Water Quality Report

Response to Submissions

4 MARCH 2011

Prepared for
Veolia Environmental Services

DIAGRAM OF LOCATIONS OF OSW1 & OSW2

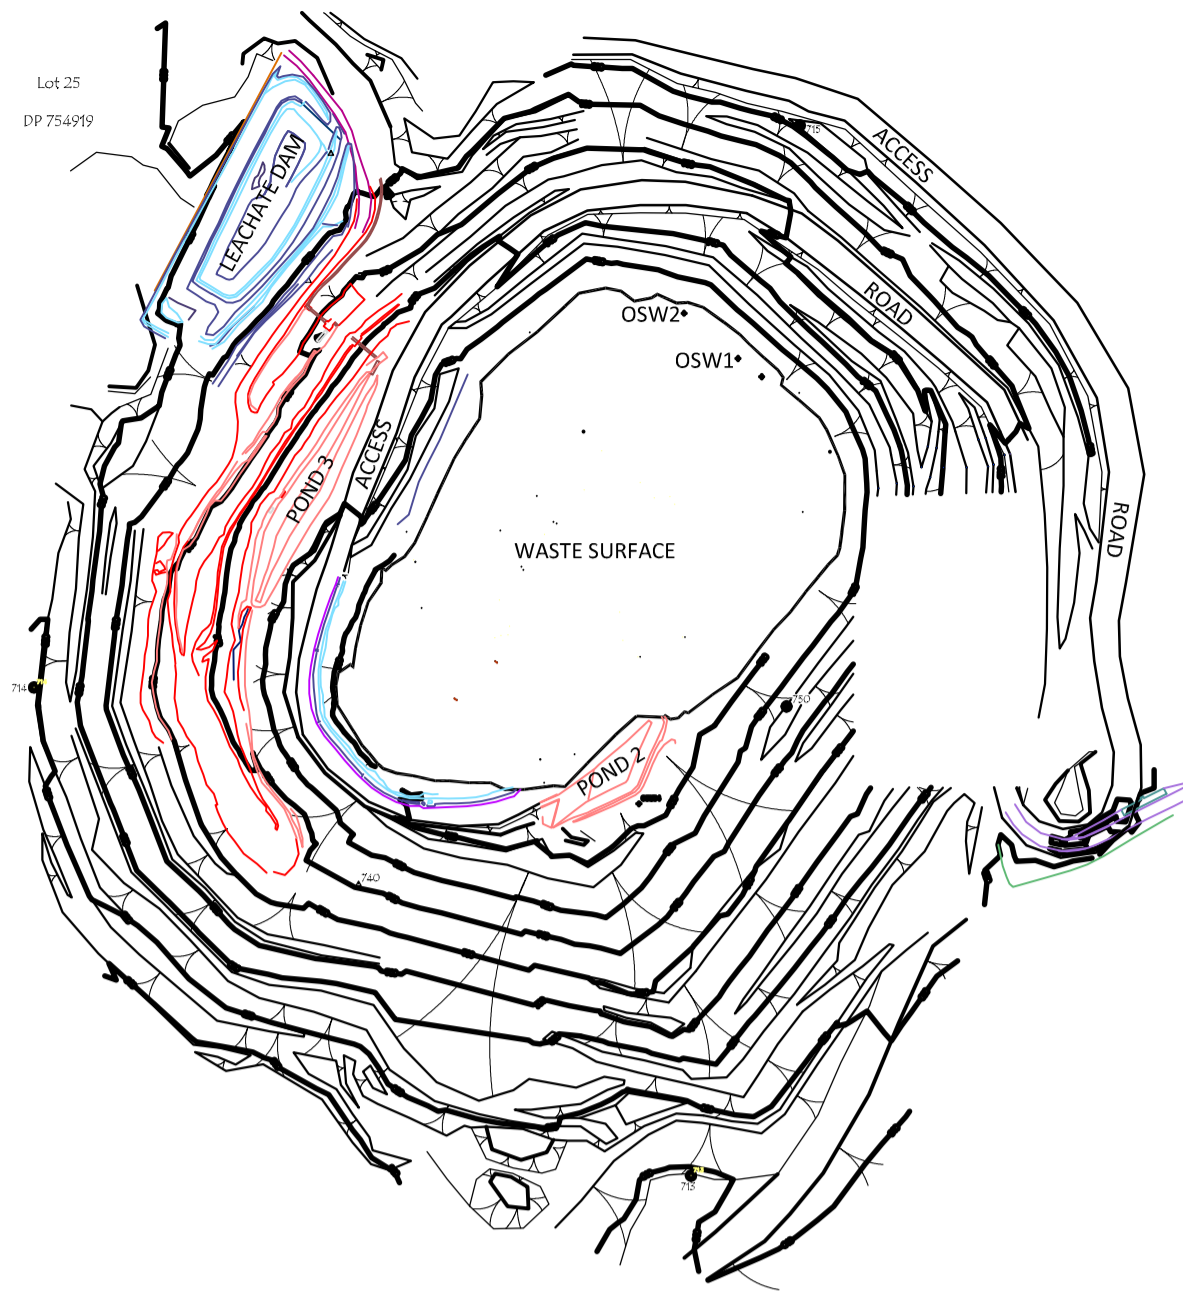
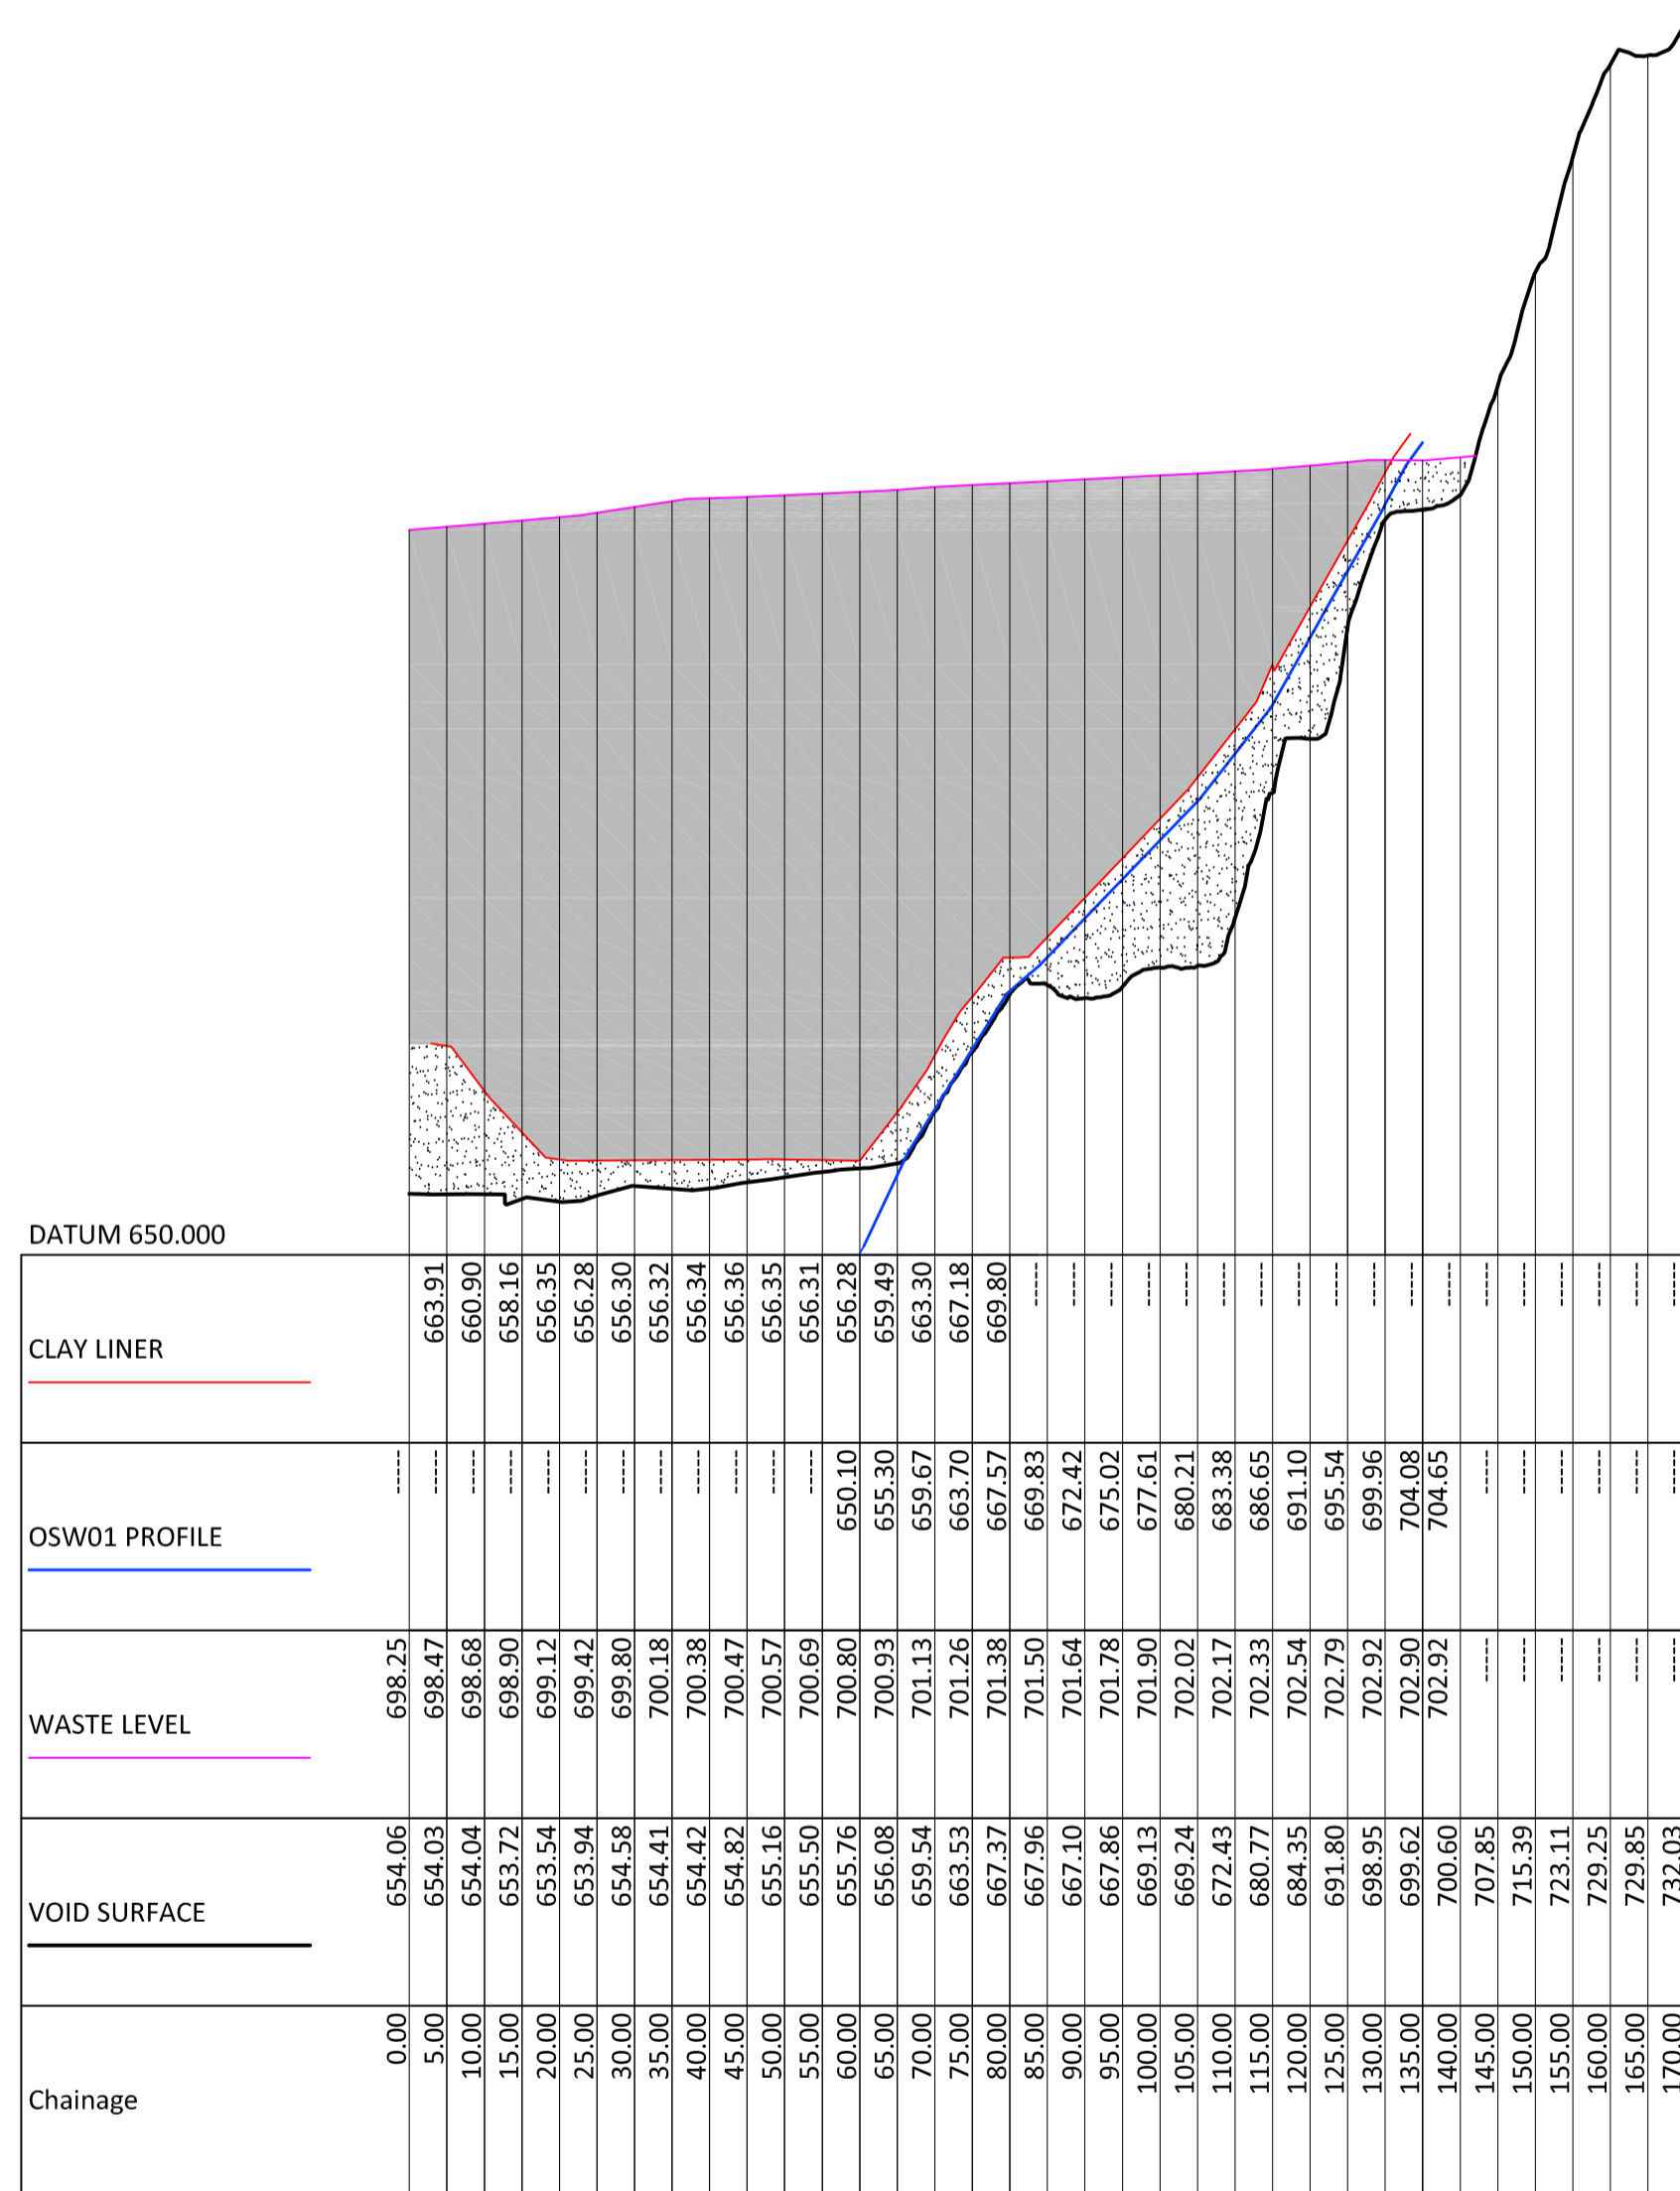
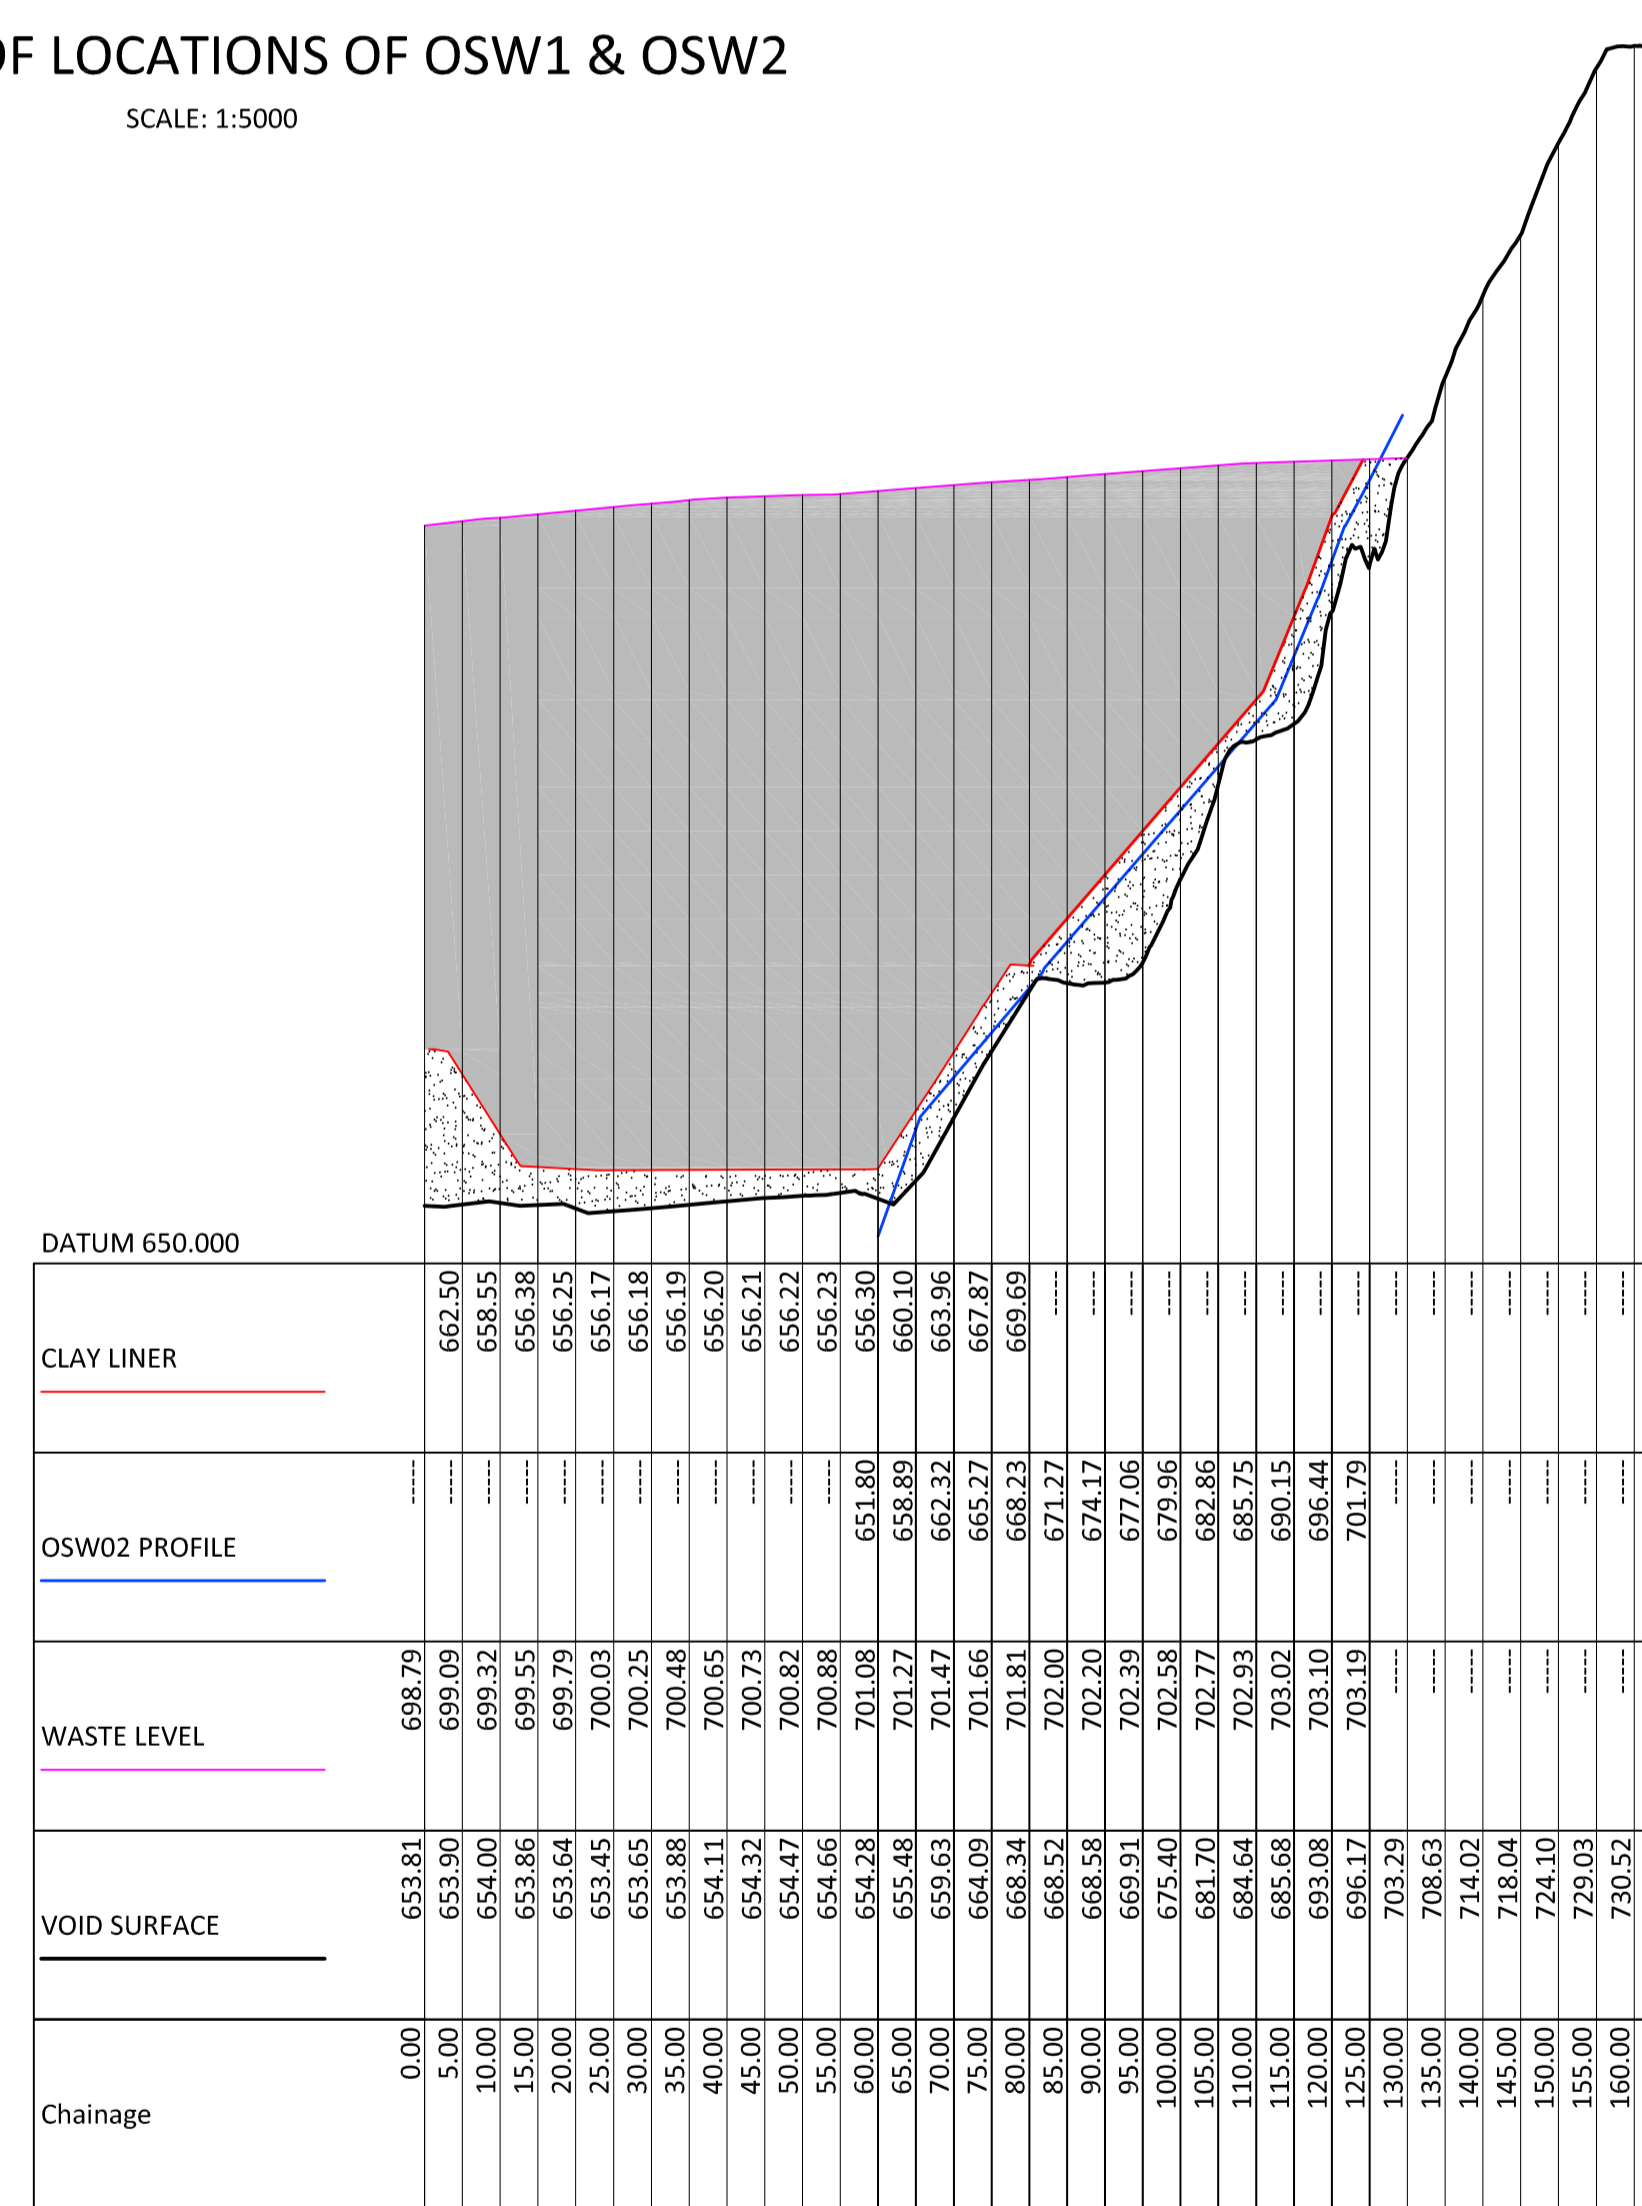
The Leachate Management Plan (LMP) refers to groundwater dewatering via two bores (OSW1 and a back up bore OSW2) however the location and depth of these bores was not clearly mapped. As this is a key component of the LMP it is requested the two bores be accurately identified on a map and a cross-section of the pit be provided to indicate the bores' location, depth and extraction points in relation to the pit infrastructure (e.g. pit walls, basal liner, drainage system beneath the liner and waste material).

The location of the two groundwater dewatering bores (OSW1 and OSW2) is shown in Figure 2-11. The two bores (one operational and one back-up) are used to dewater groundwater from beneath the bioreactor liner, as shown in Figure 2-12.

OSW1 is equipped with a submersible pump with a 5.5KW motor that is able to pump 1.5 to 2.0 L/sec against a head of 100m. The inclined borehole is extended up the side of the void as the waste level increases. The groundwater bores are used for dewatering of the mine void and the extraction will be licensed under the Water Act, in accordance with the advice of NOW.

Figure 2-13 Woodlawn Groundwater Contours - 1997

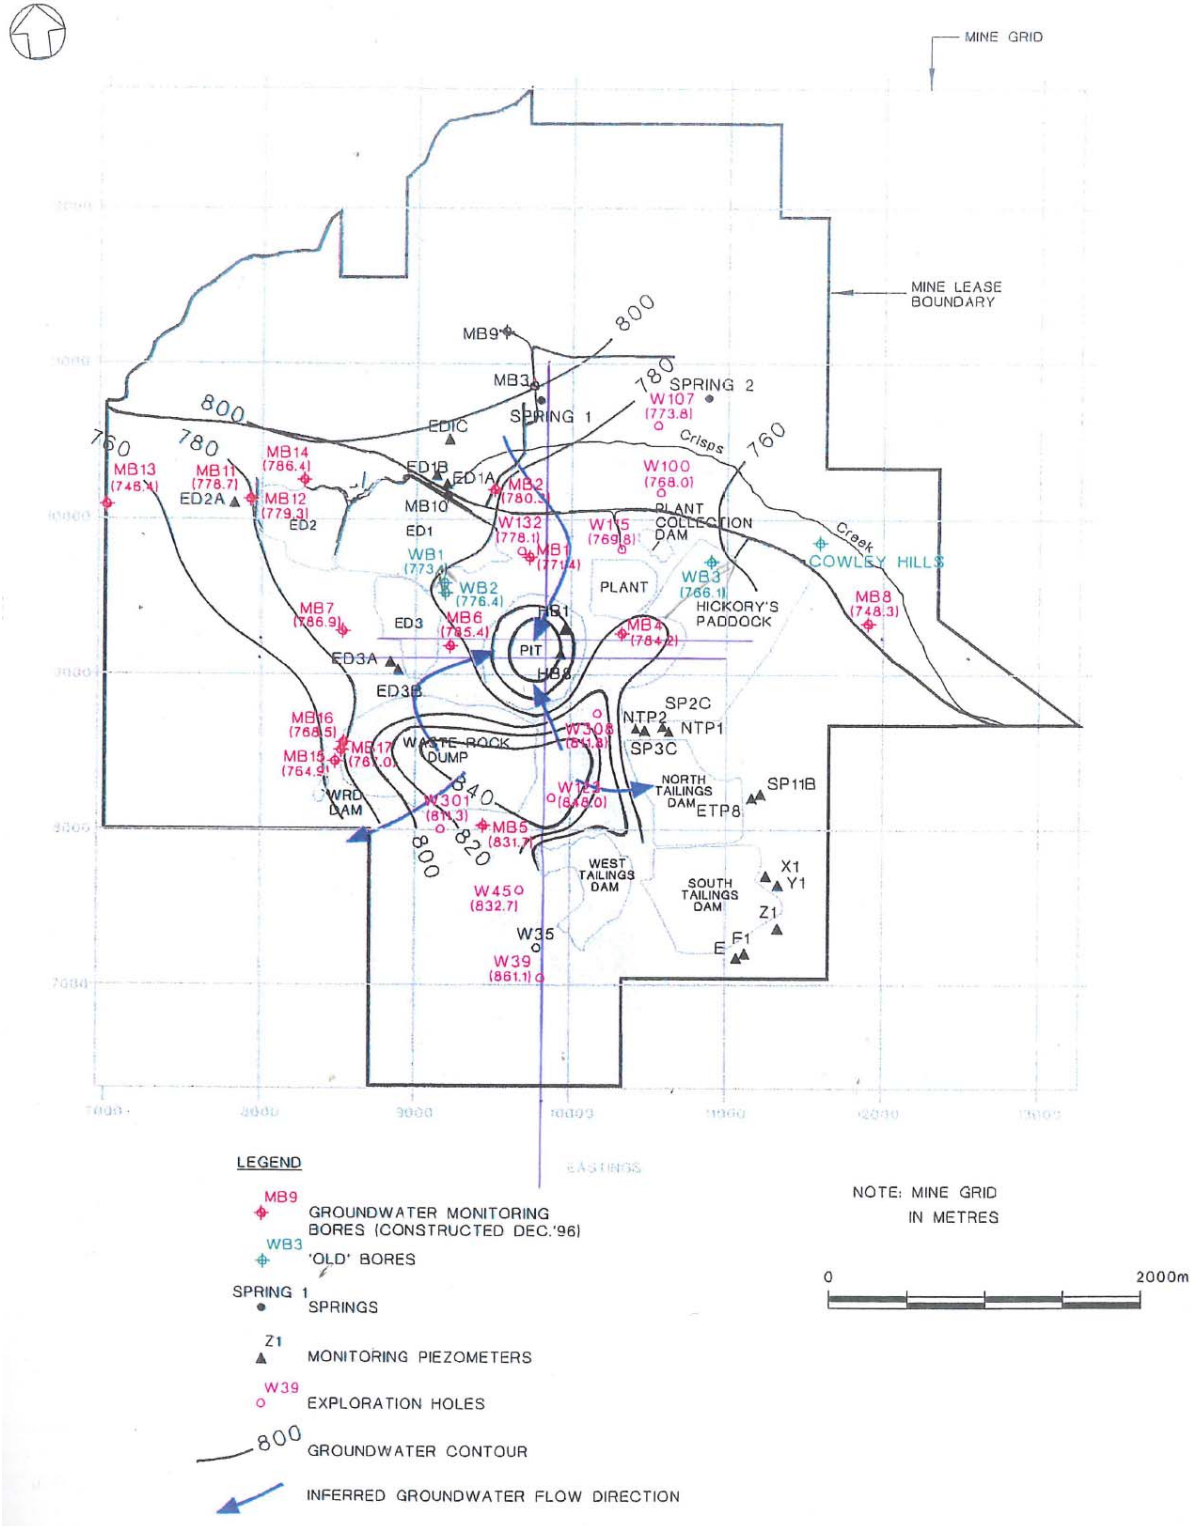
Confirmation is also requested as to the impact of the dewatering bores in relation to the groundwater level over time. It is recommended the water balance of the LMP include a graph of groundwater levels from a number of monitoring bores and this be related to the pit infrastructure and dewatering rates, and be updated as part of the Groundwater Monitoring Program.

Open cut mining at Woodlawn commenced in 1978 and in 1997 Woodward-Clyde (now URS) plotted groundwater levels in the bedrock around the mine void. These contours, which are reproduced in Figure 2-13 show the cone of depression created by the open cut mine. The groundwater levels range from as high as 840mAHD beneath the waste rock dump on the southern side of the pit to 760mAHD to the east and west of the mine. These groundwater levels are within the bedrock and are a completely separate system from the shallow water table conditions that exist along the Crisps Creek alluvium where spring flows are observed.

The 1997 contours (Figure 2-13) show the impact on groundwater levels in the bedrock after 20 years of depressurisation during open cut mining, when the pumping sump was located about 180m below the regional water table level.
